**CERTIFICATE OF APPROPRIATENESS**

**RE: Application Number 21-7580; 2277 Longfellow, Boston Edison Historic District**

**APPLICATION NUMBER: 21-7580**

**SCOPE: REBUILD REAR ADDITION, REMOVE REAR PORCH, REPLACE ALL WINDOWS/DOORS AND ERECT FRONT PORCH**

**Plan to build railing similar to pictured, height will be 36" per code and railing will be built onsite.**

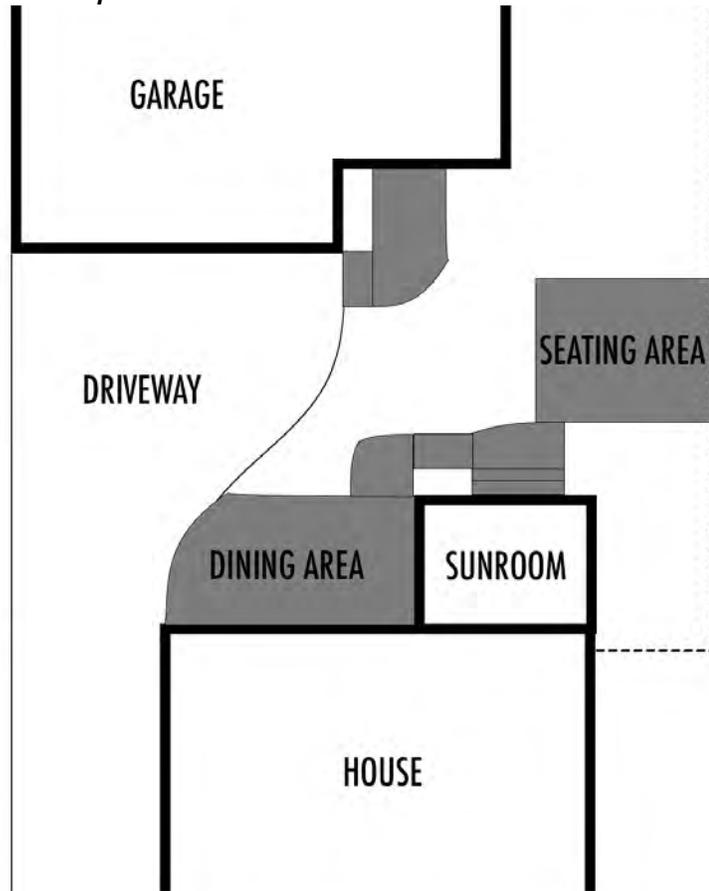
- A photo was submitted for a second-floor porch railing (document Q & A page one) at a Chicago Boulevard house, but the elevation drawing shows a railing with straight spindles. Please clarify. Also check the building code as I'm not sure a similar design would be allowed today (due to narrower spacing railing requirements). A catalog cut for this proposed railing will be needed. [This railing would be built onsite to match design but height would be to code.](#)

- **A final railing design for the rear second floor porch, confirmed to meet the building code, will be submitted to staff for review.**
- **If the historic shutters are no longer present on-site, and the property owner wishes to install new shutters on the front elevation, the replacement shutters shall match the dimensions of the historic shutters and be one-half the dimension of the window rough opening. The selected shutter will be submitted for staff review prior to installation.**

# SUNROOM WINDOWS

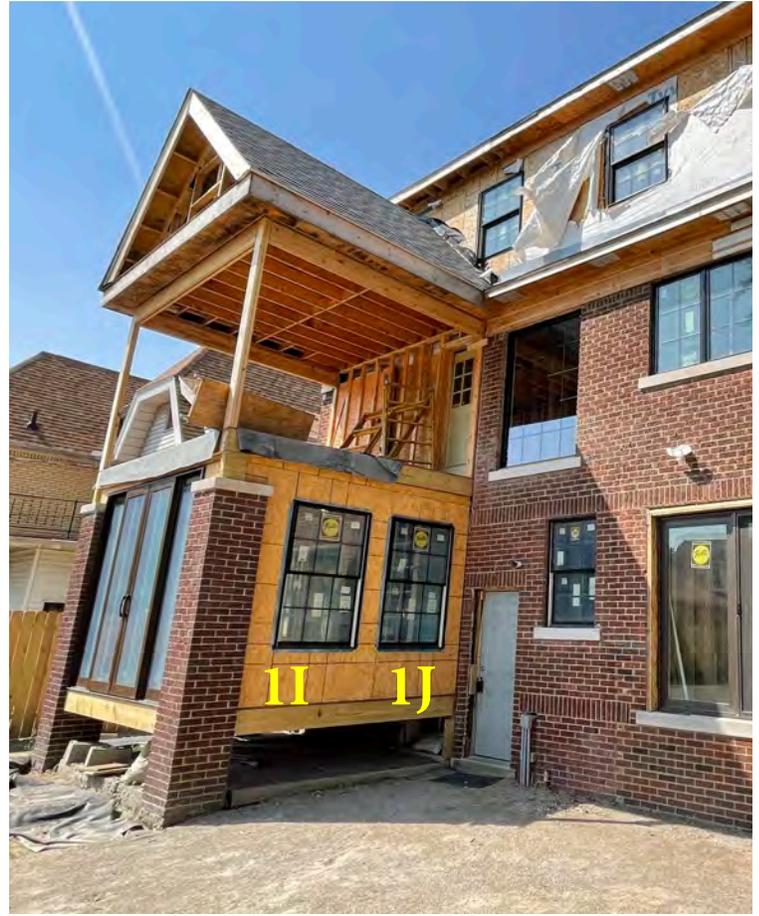
- Drawings don't specify if or how the area between the sunroom floor and the lawn will be enclosed. Please clarify.
- The drawings don't show what type of windows will be inserted into the east and west walls (nor the type of sills). The window order also doesn't specify these openings. [Sunroom will have lattice below to enclose](#)  
[See revised window guide for sunroom windows](#)

**SUNROOM WEST ELEVATION  
WINDOW 1G (left) and 1H (right)**

**SUNROOM EAST ELEVATION  
WINDOW 1I (left) and 1J (right)**

# REAR STAIRS TO SUNROOM

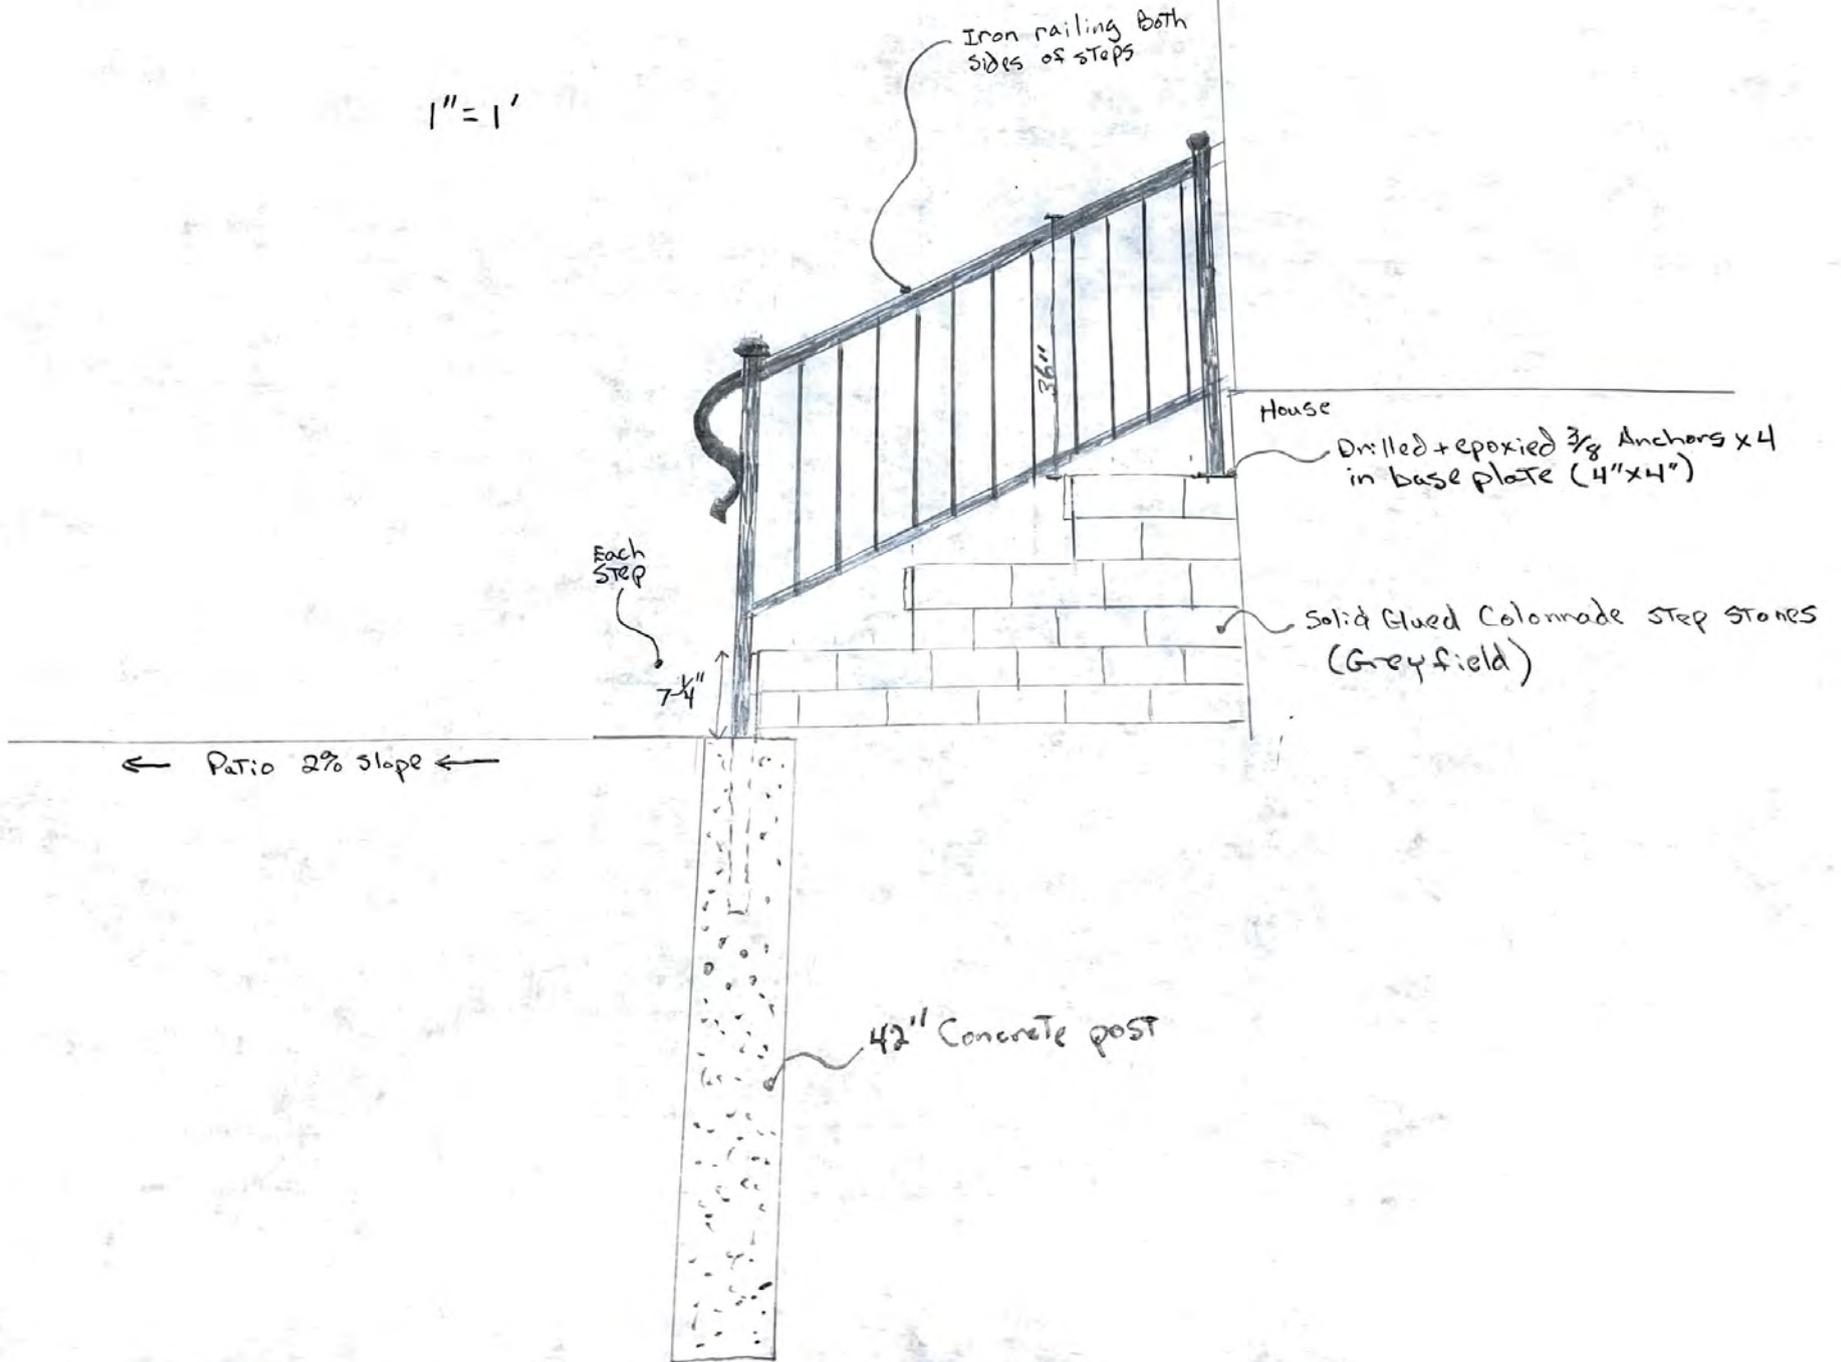
- Paver stairs leading from sunroom to rear yard. Please submit dimensions (both on the site plan as well as elevation drawing) for the stairs. [Submitted in new site plan](#)

- Steps from sunroom door will be width of sunroom door straight down, the material will be the same pavers used in hardscape.

FRONT PORCH w/ ELEVATIONS

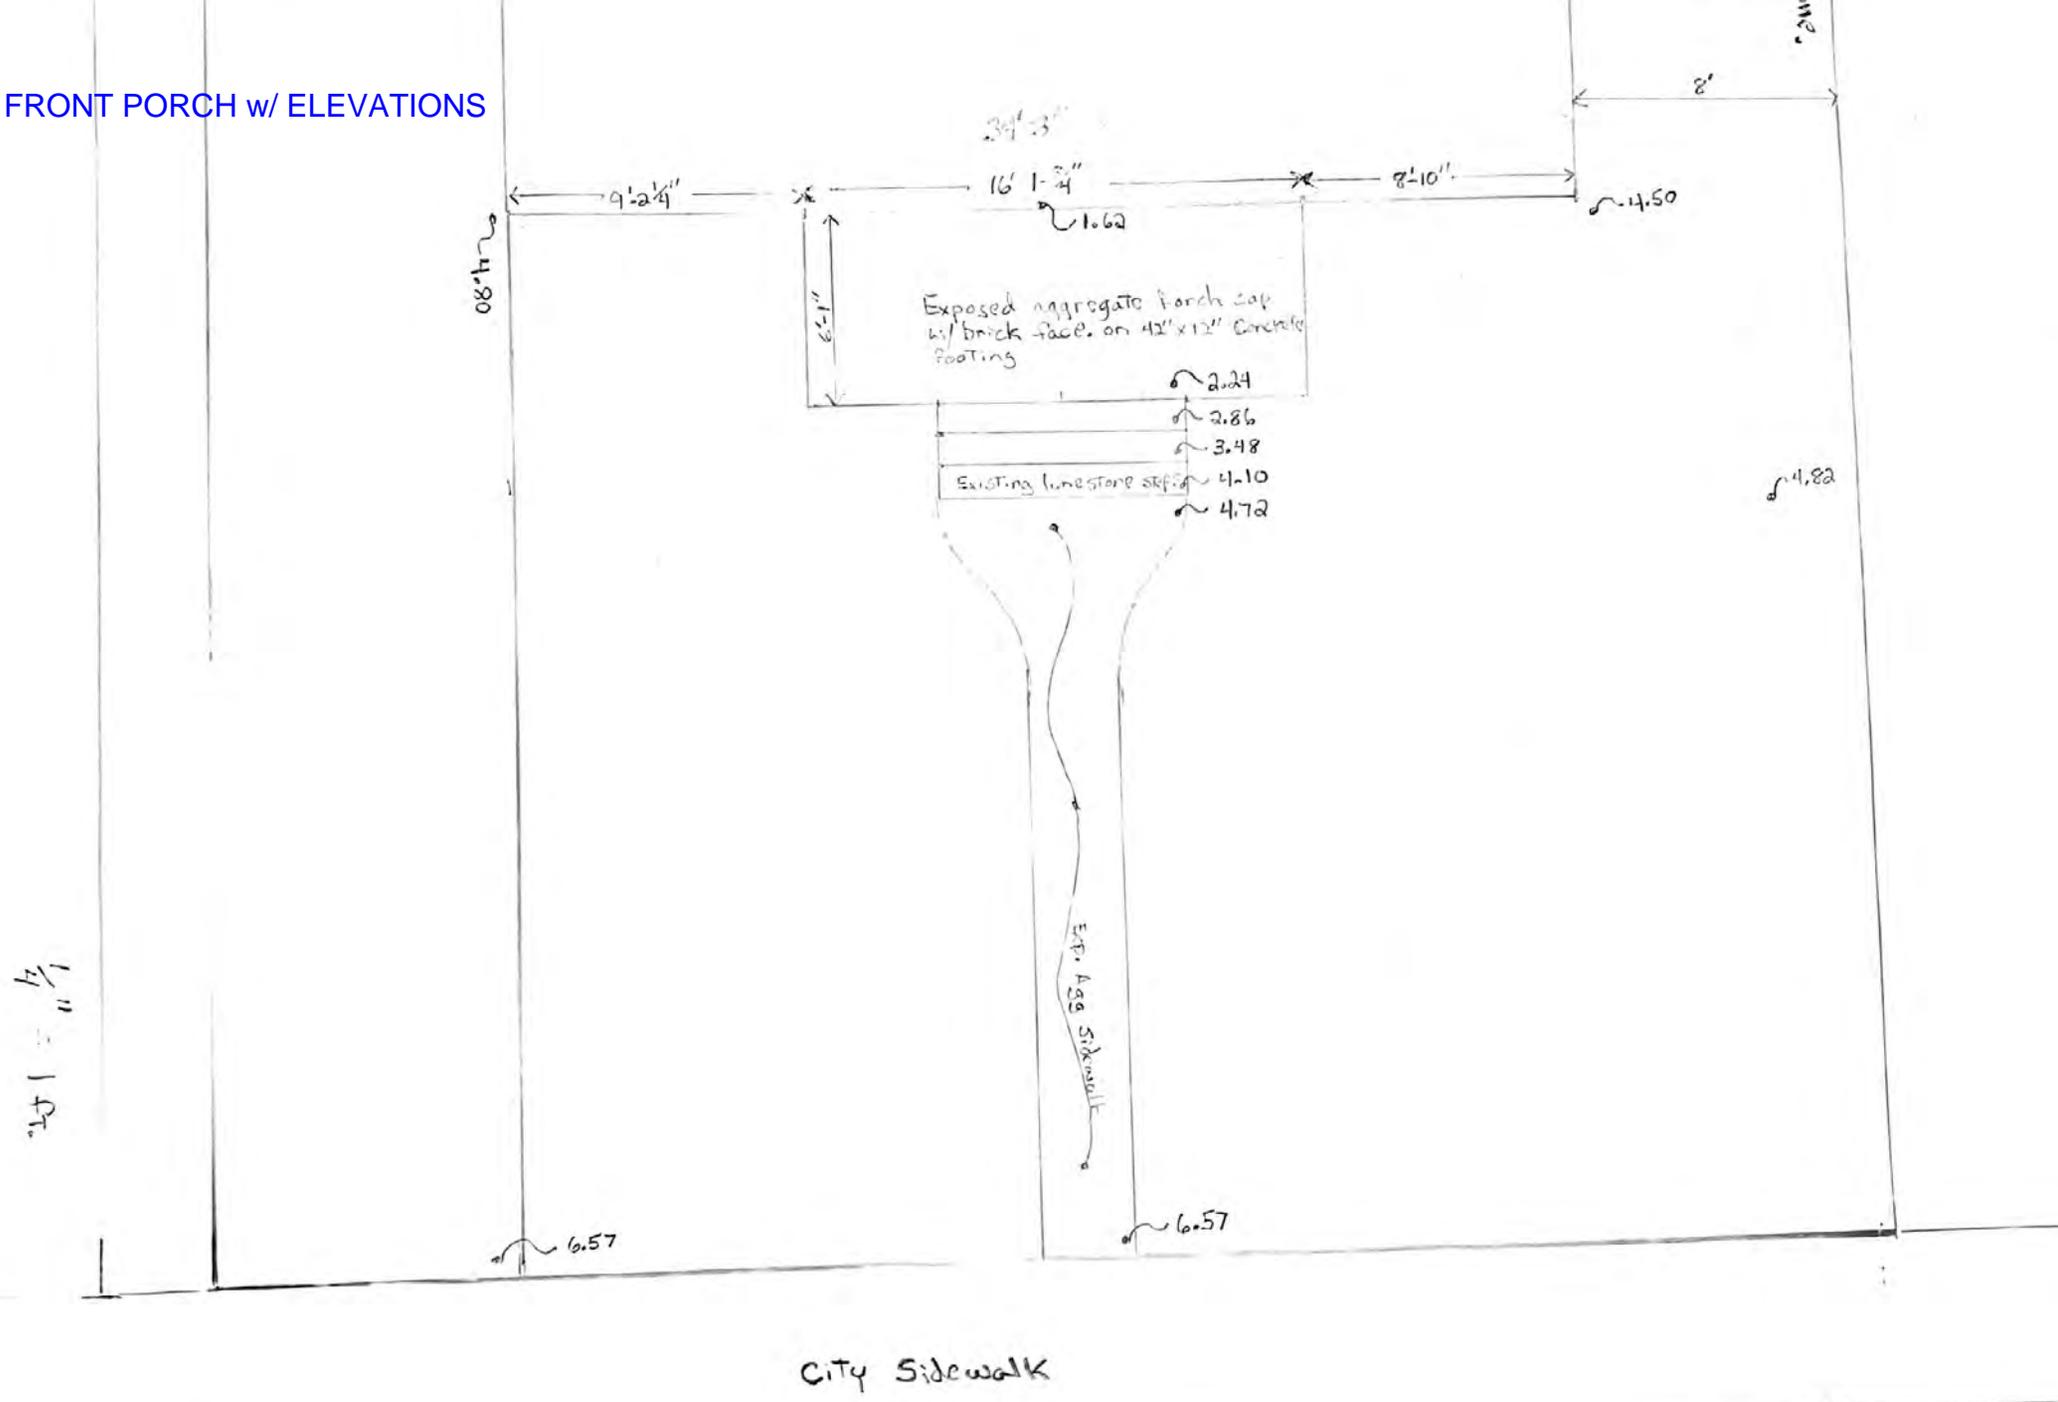
- The original width of the porch was not much wider than the front door surround. Recessed wing walls flanked the stairs, causing the stairs to be only slightly wider than the front door. The newly installed wider porch, and its very closely matching brick and mortar joints, offers a minimal visual change to the front of the house.

- Design of front porch isn't clear; the dimensioned site plan will help clear up the confusion over the footprint and dimensions of each porch element. [Revised site plan attached](#)
  - Elevation drawing shows porch extending to the outer edges of the flanking windows. However, the original porch didn't extend beyond the inside corner of the flanking windows. Page A-3 shows the profile of the front steps -- are the wing walls not being reconstructed? Also shown on Page A-3 is a railing – will it only run the length of the stairs as shown? Or, will it extend from the stairs to the house, thereby enclosing the porch? A catalog cut is needed to confirm, dimensions, design, material and finish for the railing.

- **The between-the-glass grids on all of the front elevation windows will be removed, turning the units into one-over-one sash.**
- **The brick wing walls will be erected to flank the front porch steps and the black railing will not be installed. The wing walls with limestone caps will match the design, dimensions, and placement (adjacent the stairs) of the original walls.**

PROPOSED EXTERIOR FRONT

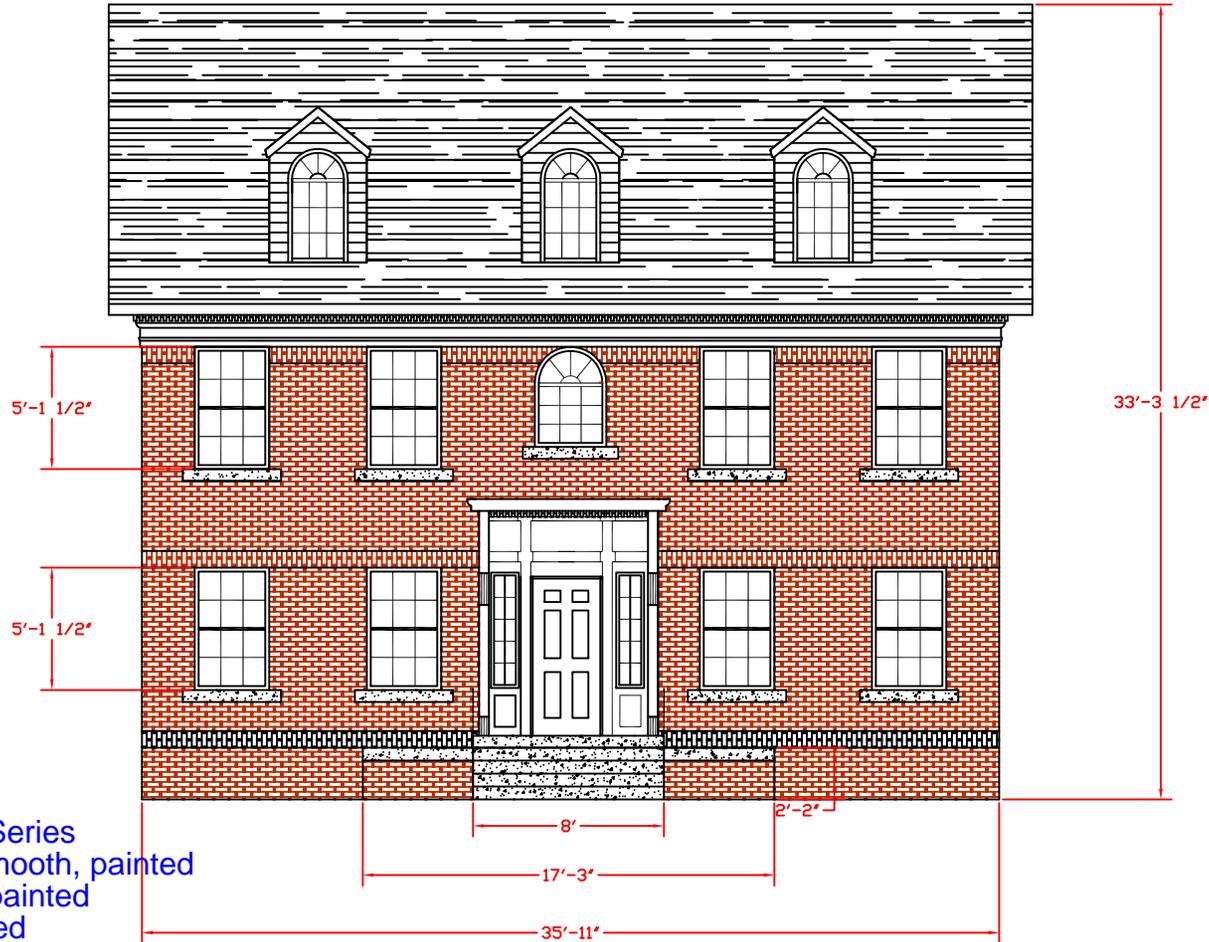
- The original dormer windows, and central 2<sup>nd</sup> floor window, were double-hung units with arched upper sashes. By 1980, rectangular storm windows had been installed, muddling the appearance of these openings as well as the window function/design. [Casement window provides the closest look to original, a double hung window with the top sash arched like the original is not possible today \(per Pella\). The sash would be too small. The arch must be a separate sash, casement works best](#)

[Window numbers fixed, see email for grille explanation](#)

PROPOSED EXTERIOR\_REAR

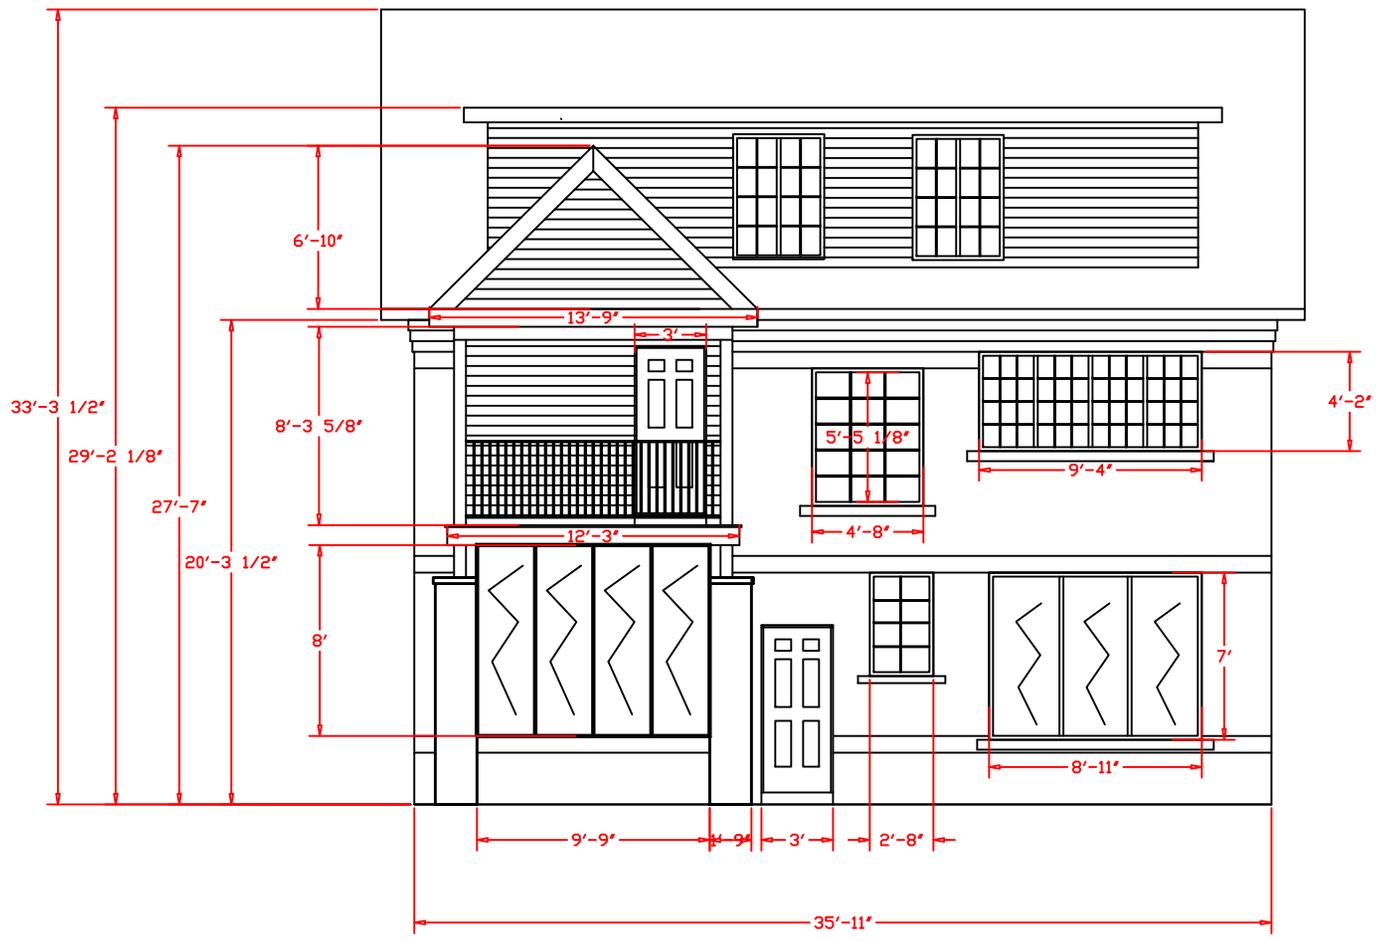
- Where is the window order for 1J? I suspect this opening is identified as 1K on the window order. Please correct. [Correct](#)
- 2F – the elevation drawing shows two double-casements in the shed roof, but the window order specifies two (single opening) double-hung windows. Please correct (either the elevation drawing or window order). [2 Double hung](#)
- 2I – the elevation drawing shows a 3w/5h muntin pattern, but the window order specifies a 4w/5h pattern. Please correct. [4w/5h muntin pattern is correct](#)
- 2J – the elevation drawing shows four mulled casements each with a 3w/4h pattern, but the window order specifies a 2w/3h pattern. Please correct. Please correct, and also note the width of the three factory mullions.  
[2w/3h pattern is correct per the window order.](#)
